# Drinking Water Audit Report

<b>County:</b>	Wexford	<b>Date of Audit:</b>	7 <sup>th</sup> July 2017
<b>Plant(s) visited:</b>	Camolin Water Treatment Plant (3300PUB1779)	<b>Date of issue of Audit Report:</b>	11 <sup>th</sup> July 2017
		<b>File Reference:</b>	DW2017/91
		<b>Auditors:</b>	Mr. Darragh Page
<b>Audit Criteria:</b>	<ul style="list-style-type: none"> <li>• The <i>European Union (Drinking Water) Regulations 2014 (S.I. 122 of 2014)</i>.</li> <li>• The <i>EPA Handbook on the Implementation of the Regulations for Water Services Authorities for Public Water Supplies (ISBN: 978-1-84095-349-7)</i></li> <li>• The recommendations specified in the <i>EPA Drinking Water Report</i>.</li> <li>• EPA Drinking Water Advice Notes No.s 1 to 15.</li> <li>• The recommendations in any previous audit reports.</li> </ul>

Photo 1. Schematic of the Camolin Water Treatment Plant.

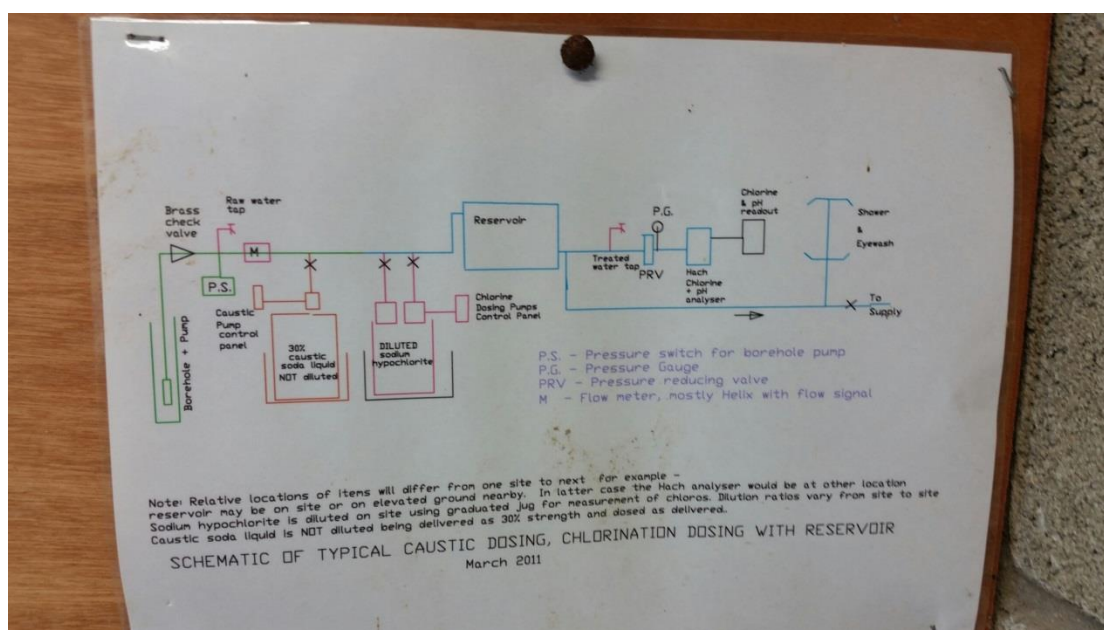
- Irish Water should review the schematic of Camolin water treatment plant and ensure that it represents the correct sequence of treatment processes at the plant.
